Burlington Design Advisory Board

DESIGN ADVISORY BOARD Tuesday September 14, 2021 3:00 PM

MEMORANDUM

To: The Design Advisory Board
From: Mary O'Neil, AICP, Principal Planner
RE: ZP21-457, 43 Adams Court
Date: July 13, 2021, **September 14, 2021**

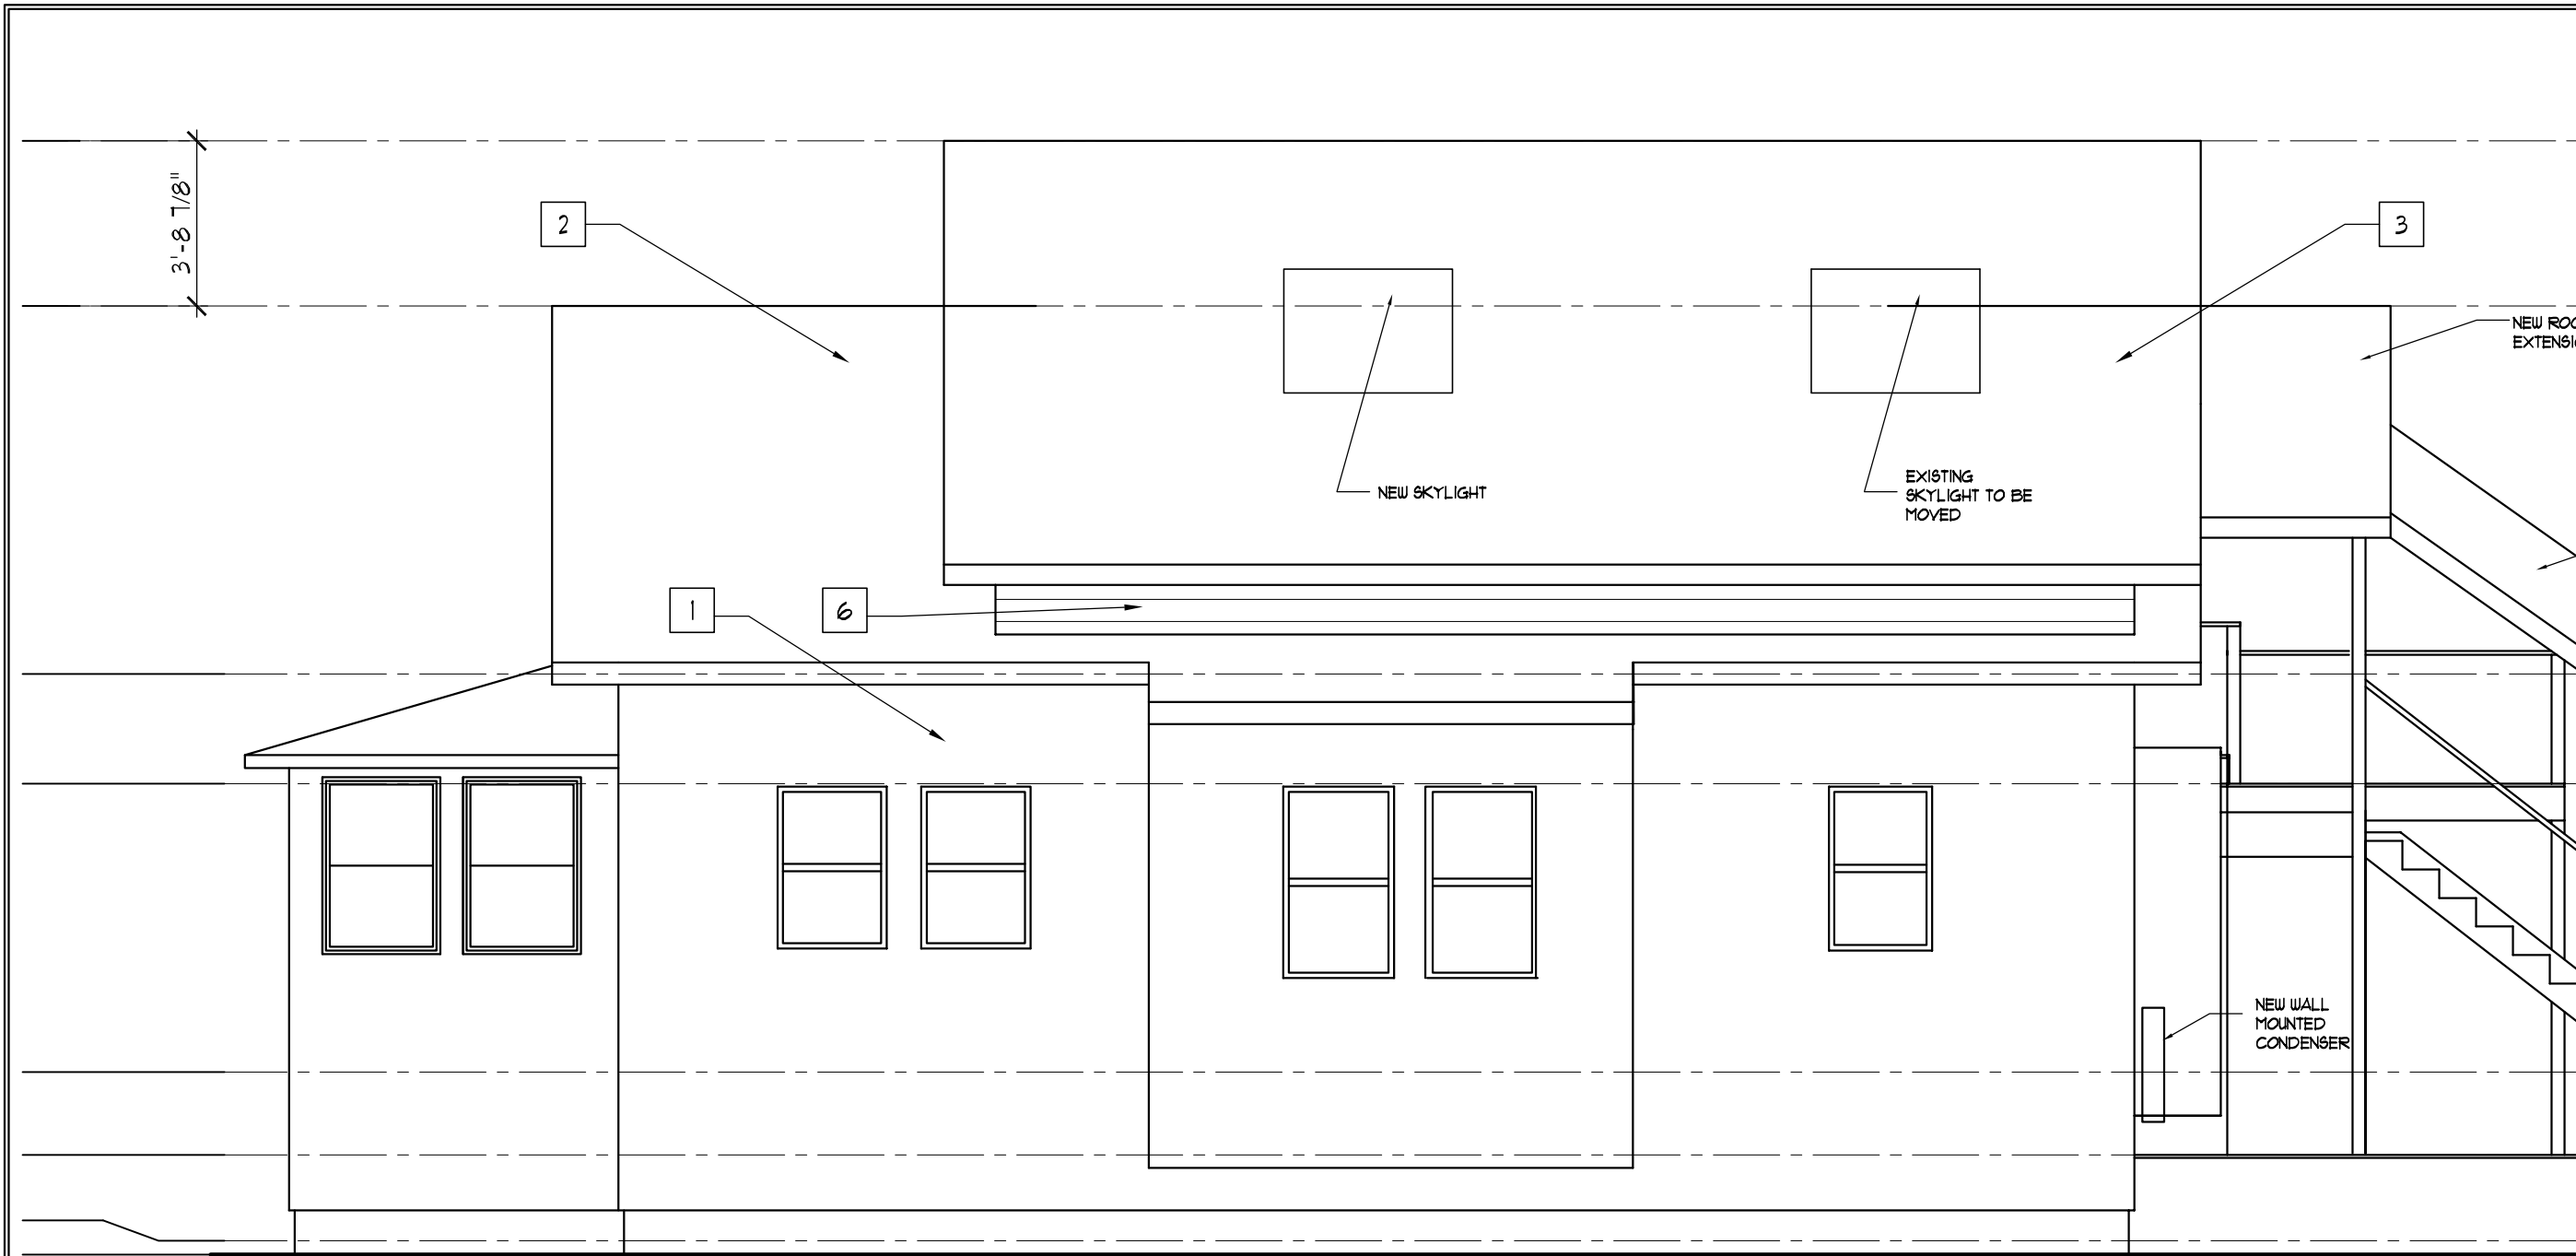
The rear deck and replacement stairway are acceptable alterations. The enlarged dormers and chimney removal are both contrary to this standard.

77-87 Pearl St. / 6 Pine St. - Site Plan

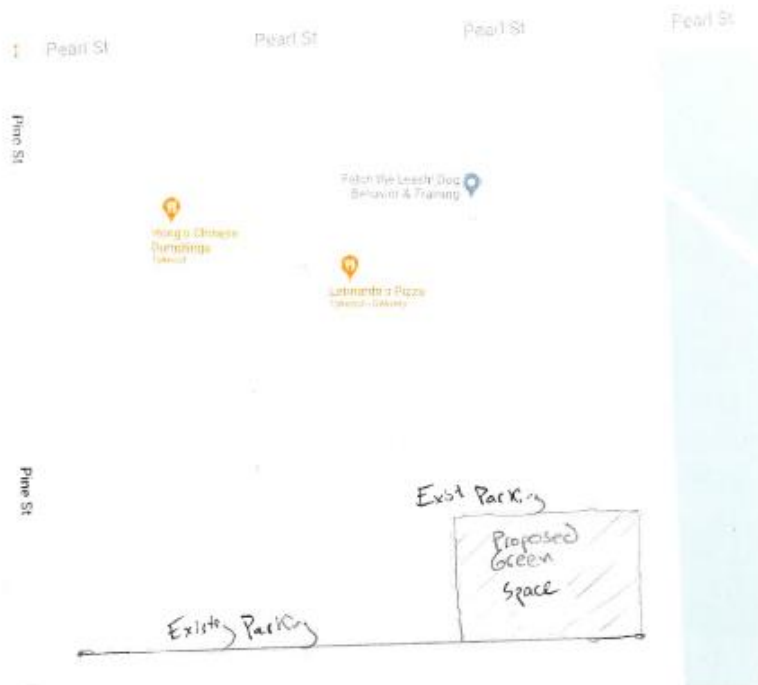
Replacement of this notable structure with a small area of green space is not a satisfactory redevelopment plan that honors the architectural and historic qualities of this or surrounding structures. While open areas are welcome for public enjoyment and use, this small area will remain private, and likely converted to parking or dumpster storage in a zoning district that allows up to 100% lot coverage. By this standard, there is no redevelopment plan; and the proposal has a significant negative effect on the architectural and historical qualities of other structures and the character of the neighborhood around the site.

The submitted plan is an annotated Google image with the location of the barn identified as green space. An overall coverage calculation has not been submitted.

PHOTO 1: South-West Corner - Note ridge sag, swale in roof plane and hole in roof near chimney

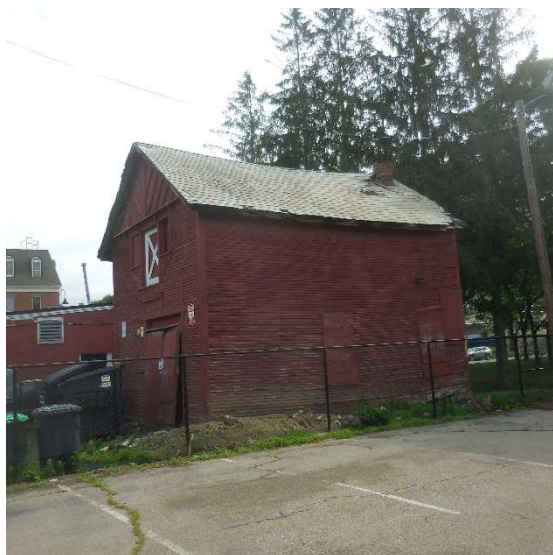
1. Wood framed walls bear on a foundation that appears to be 6” or more below grade. Wood components (mudsill, studs, sheathing, etc.) that are at or below grade show signs of decay and deterioration (PHOTOS 3 & 4).

2. There is a significant sag in the roof ridge and visible “swales” in the roof plane on either side of the ridge (PHOTO 1); both sag and swales seem to indicate excessive deformation of roof framing elements.

1984-85 Assessor Revaluation photograph
Stairs are new build

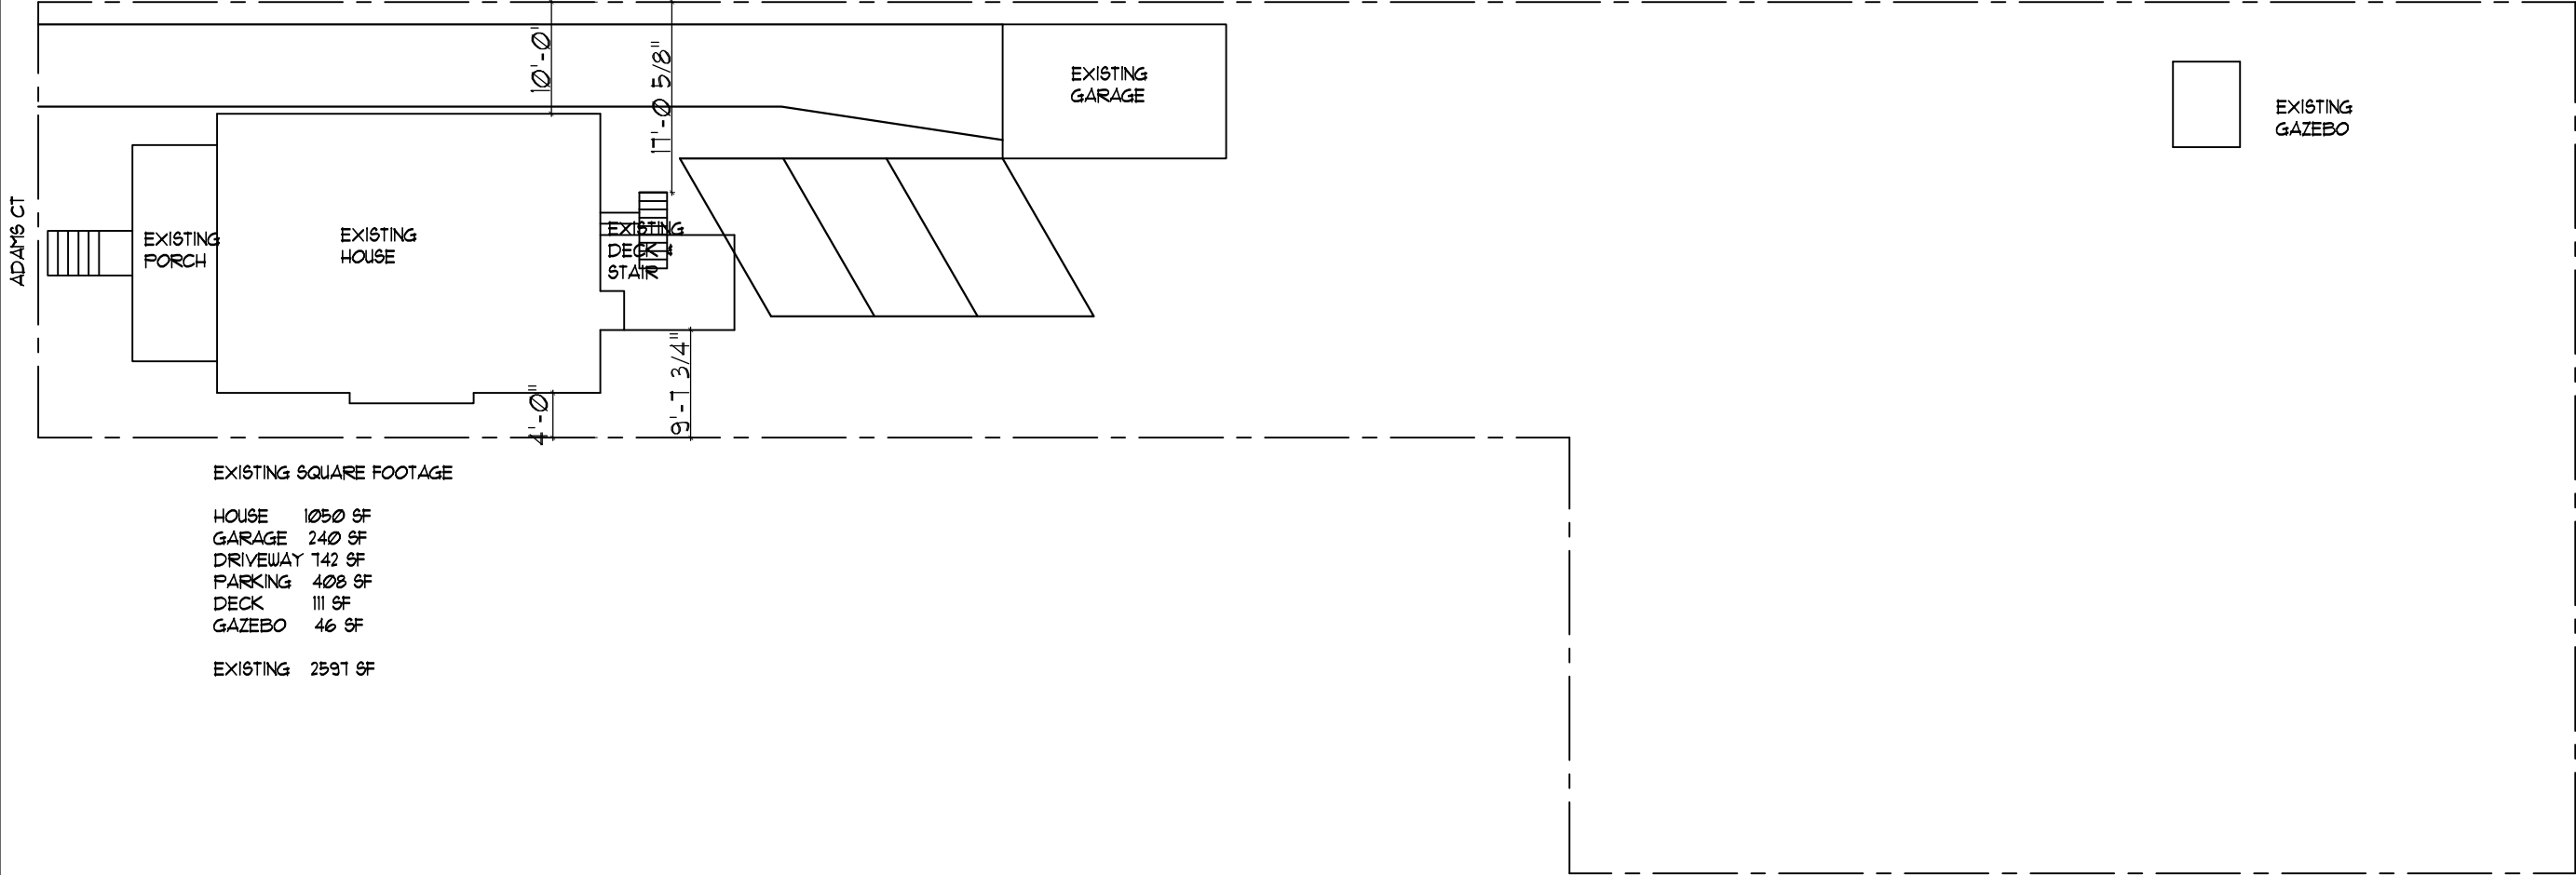
The method of support for this replacement staircase is distracting and is an adverse alteration to the historic porch/house. It can and should be removed and a different solution sought to protect the historic integrity of the residence.
